Conceptual Review Agenda

Schedule for 06/23/14 to 06/23/14

Front Range Village Senior Multifamily

Comment Summary:

SITE PLAN

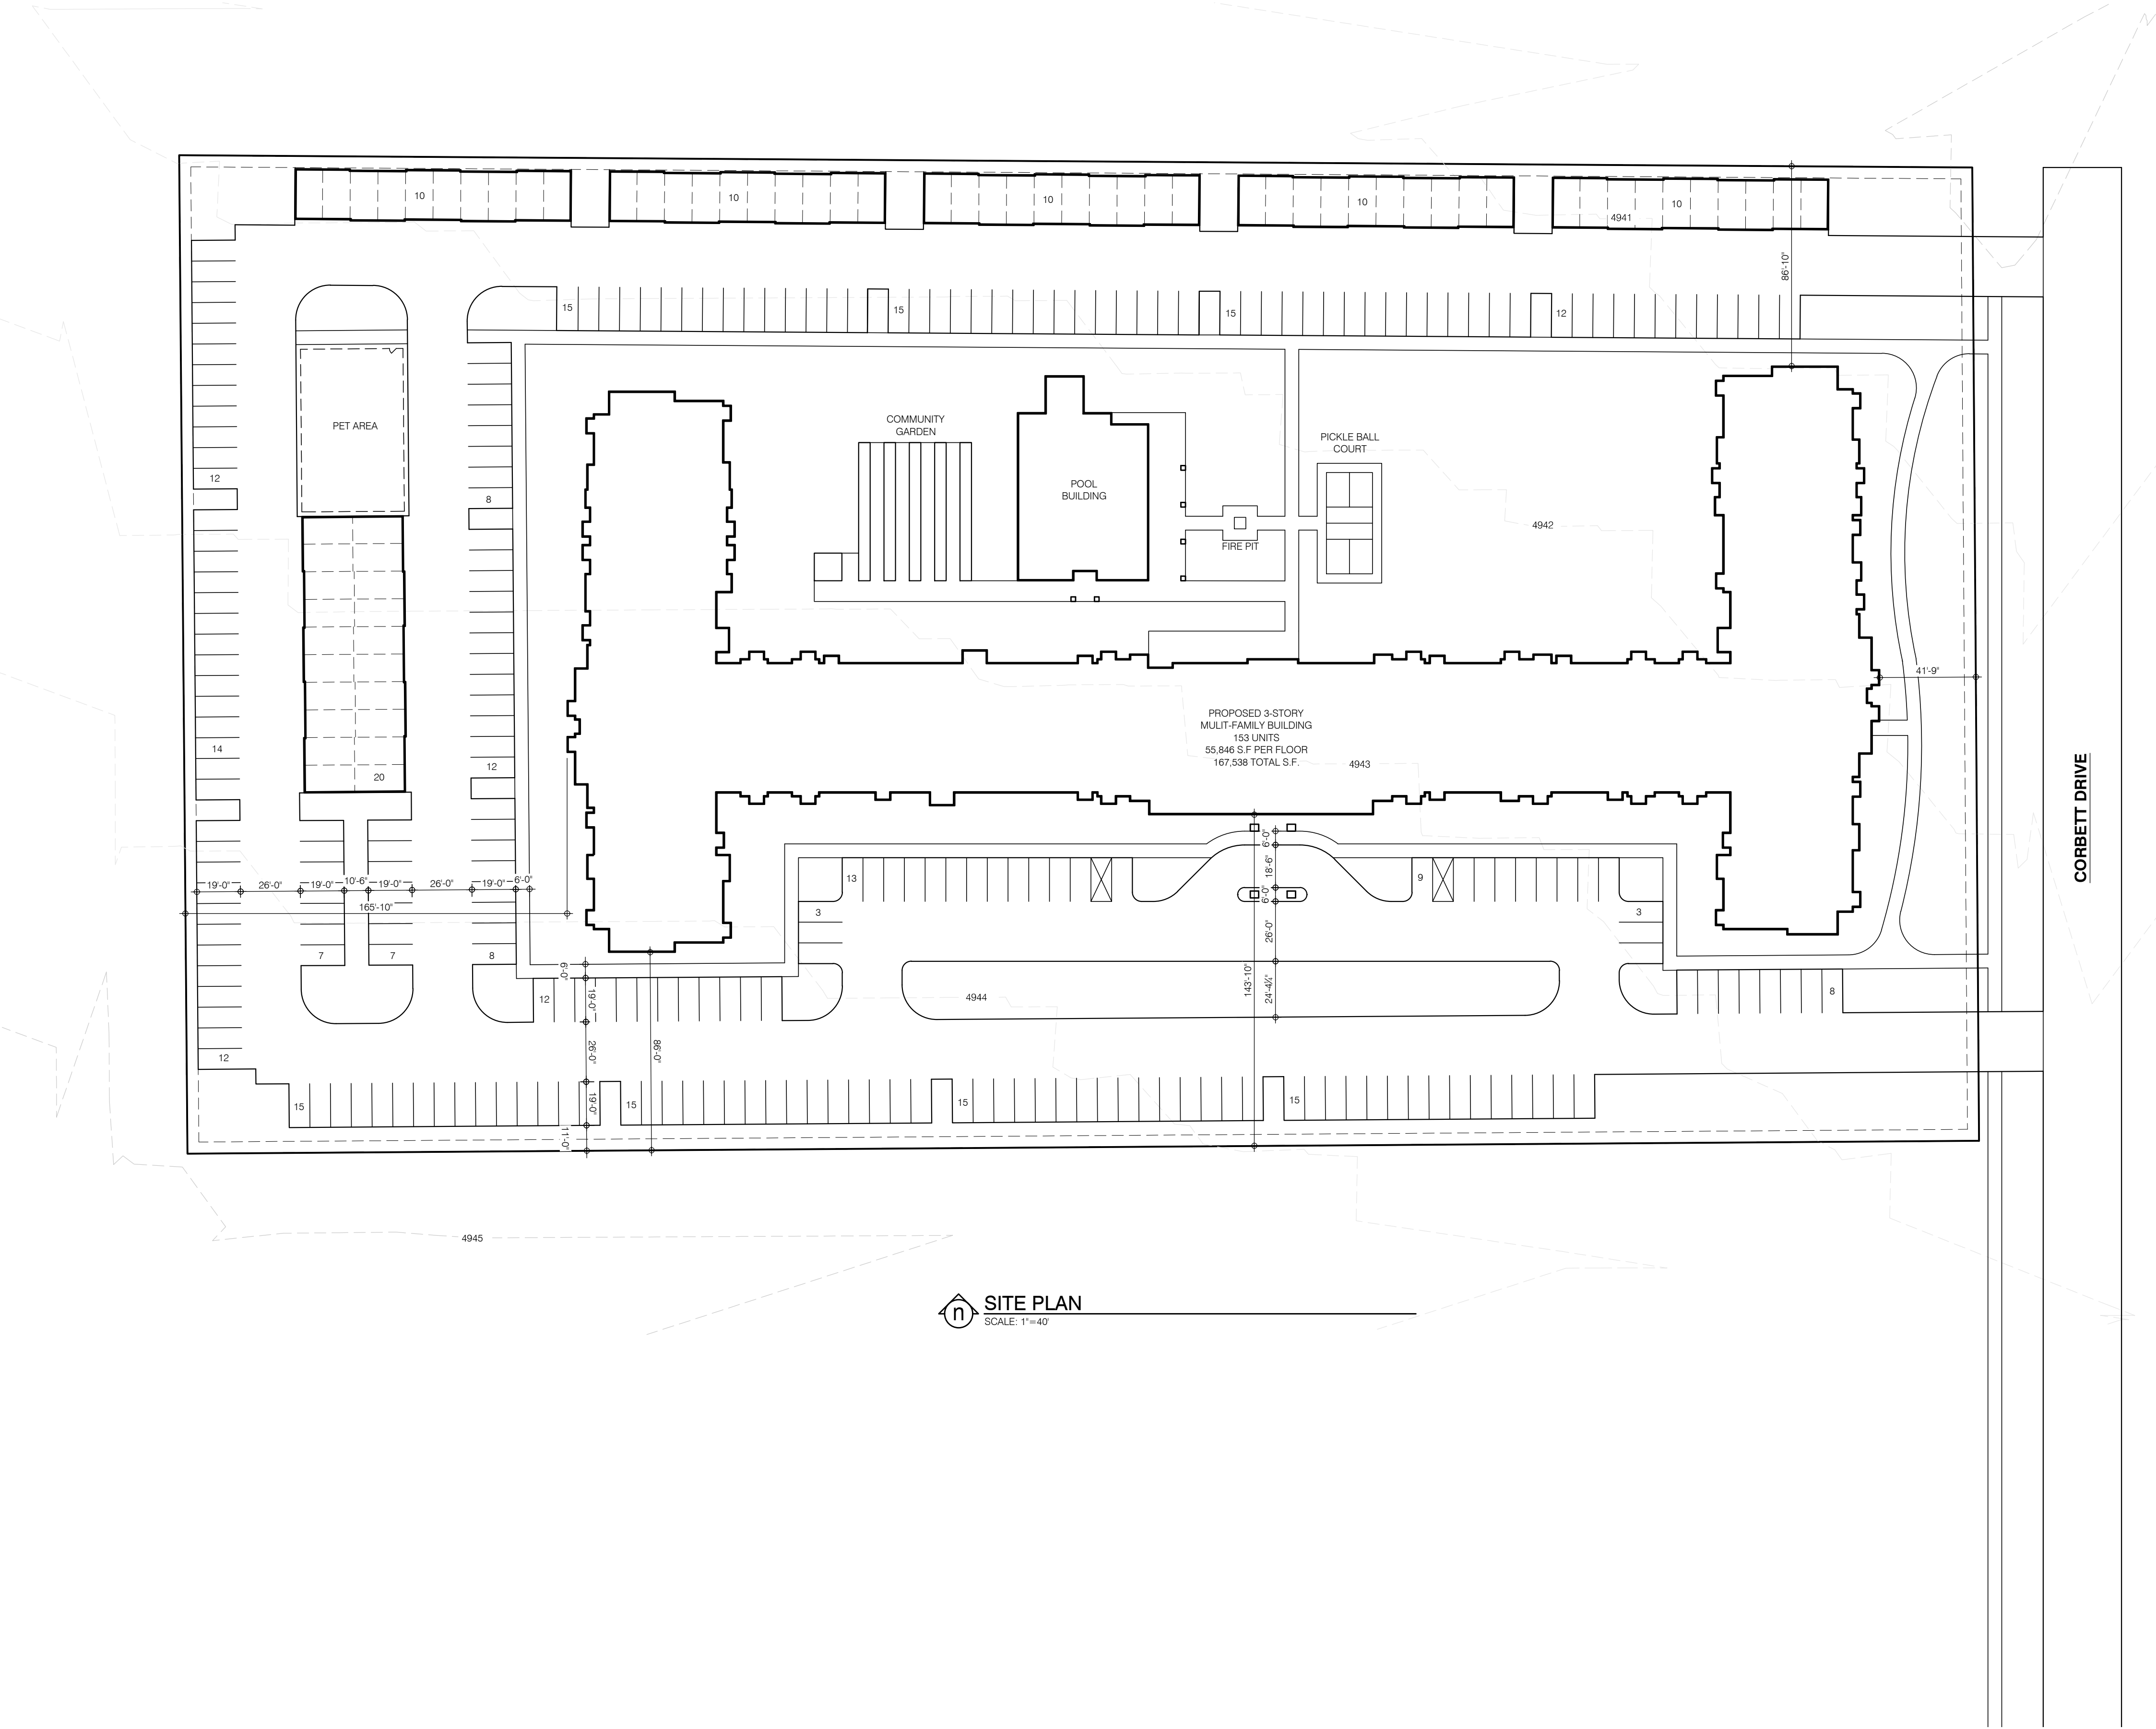
1. The narrative states that there are 'fewer driving residents per units', yet the plan shows considerably more parking than the minimum requirement. Do you need to provide that much parking?
2. The parking lot must comply with the parking lot design standards in Sec. 3.2.2 of the Land Use Code and with the parking lot landscape standards in Sec. 3.2.1.
3. While only 8 handicap parking stalls are required, are you planning on providing extra given that this is a 55+ age group?
4. An adequate number of trash enclosures are required.
5. Show bike parking on plan. A minimum of one bike space per bedroom is required, with 60% of them being in an enclosed bike parking area.
6. The multi-family design standards in Sec. 3.8.30 will apply.

10. A public roadway must be ended in a cul-de-sac (permanent or temporary if the street is planned to be extended). In this situation the roadway will not extend further north so the road would need to be ended in a permanent cul-de-sac. The code also specifies the allowable maximum cul-de-sac length (See Section 3.6.2(D)).

11. The Master Street Plan does not show Corbett Road extending this far north as a collector roadway, so likely we would be looking for the road to be reduced in width, since an extension and dead-end here would not be of collector level roadway.

12. There has been discussion that a roadway connection should be stubbed to the west to the edge of this property. This would be in compliance with Section 3.6.3(F) of the Land Use Code which requires connections to adjacent parcels. The need is based on the potential for that site to redevelop and the need to provide a second point of access into the site.

7. 5 Buffer yards adjacent to single family residences: Section 3.8.30 requires 25-foot wide buffer yards. This is a significant issue with the proposed site plan. A Modification would be required. A point of discussion would likely be whether there is a solution that is equal or better than the standard in accomplishing the purpose of compatibility.

8. 6 Block size for multi family development: the Land Use Code promotes an interconnected neighborhood pattern of streets and blocks of limited size – 7 acres maximum. A Modification would be required for the site plan as proposed. The existing development on all sides would be the primary consideration.

9. 7 Note that the Modifications could be brought to a hearing for a decision without investing in a full development plan set.
10. 8 Site Plan: The walkways would need to be enhanced with more generous design features such as more width, trees in cutouts along the parking similar to street trees, corners eased with generous curves rather than strictly following parking lot outlines, and possibly pedestrian light fixtures. This design would be related to Modifications to the block size standard.

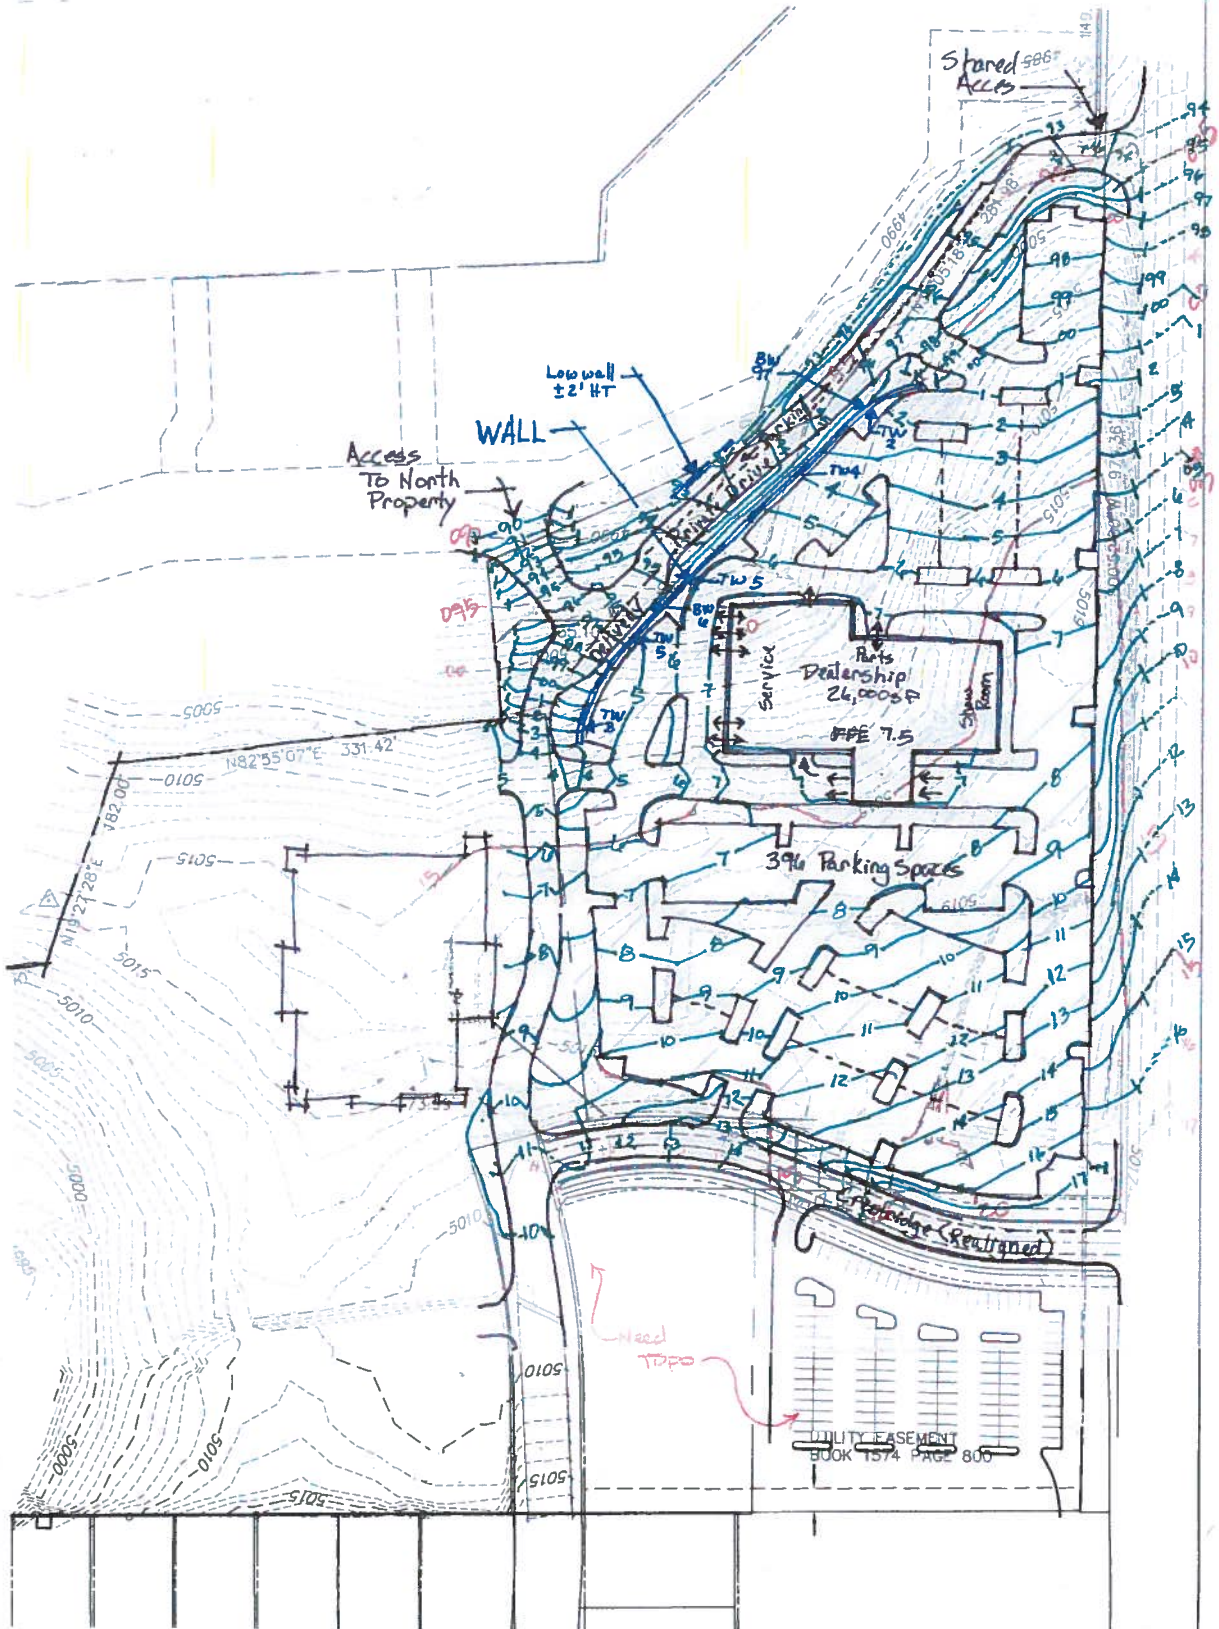
11. Venus Drive or an adequate access needs to be extended north thru this site to serve the parcel to the north. Adequate design and dedication of row/easement shall be provided. The plan that was submitted shows a private drive making this connection, which looks like that will work for this.

14. The property just to the North of this site has a vested approval for layout and density. How does this approval affect this site? That approval shows an access thru this site off of Venus and shows the location for the northern right-in right-out access point out to 287. This project will need to accommodate and provide for these access points. A change to the access locations can be made if the owner of the Waterstone property formally agrees to this. Any change to the access points or tie-ins with the access points or adjacent property needs to show how this/these connection(s) would occur and could work with the grades

16. Per the access control plan the intersection of SH287/ Crestridge Road/ Smokey Street could be signalized if the streets (Crestridge and Smokey) could be aligned, the intersection meets traffic signal warrants and the grade of the intersection approaches are reduced. If the intersection cannot be aligned then the plan shows that this access shall become a right-in right-out intersection. The conversion of the intersection to a right-in right-out configuration will probably be triggered by the additional traffic that would be added to this intersection by this development. This intersection currently has a high accident rate due to the offset in the roads and limited visibility due to not quite being at the crest of the hill. The plan submitted shows the realignment of Crestridge.

The project shows the site to front on two streets S College Ave and Crestridge. The build-to-line along Crestridge is 0-15ft. and along S College Ave 10-25ft. The building should be brought to the southeast corner of the site meeting the build-to-lines while provide a pedestrian walkway from the entrance to the sidewalk.
